<Reference: 97307925-FA>

Urgent Field Safety Notice – Product Advisory ACURATE neo2™ and ACURATE Prime™ Aortic Valve Systems (Transcatheter Aortic Valve Implantation (TAVI))

Subject: ACURATE neo2™ Aortic Valve System (TAVI) Instructions for Use and Physician Training Updates, and recommendations for ACURATE Prime™, related to Valve Under Expansion Risk.

Figure 1: ACURATE valve under fluoroscopy - valve under expansion is recognized as a non-parallel Commissure Post

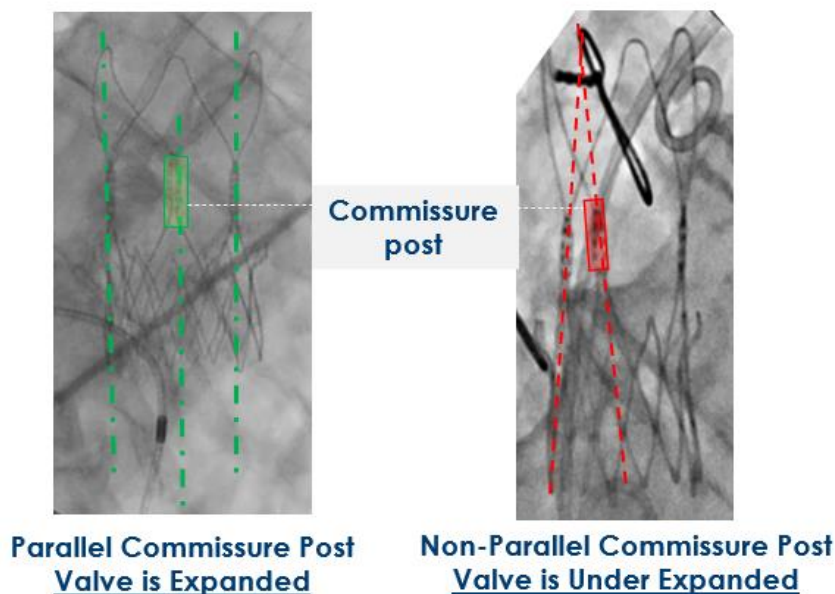
Valve under expansion can be seen under fluoroscopy (as shown in **Figure 1**) during the index procedure and mitigated with appropriate pre-dilation and post-dilation practices. Therefore, Boston Scientific has updated the ACURATE *neo2* IFUs for the risk of valve under expansion and the practices that may reduce this risk, as follows:

- Increased emphasis on pre-dilation with an appropriately sized valvuloplasty balloon.
- Use of a second fluoroscopy view during the procedure to recognize non-parallel commissure posts and under expansion.
- Post-dilation, in accordance with IFU, to improve valve under expansion.
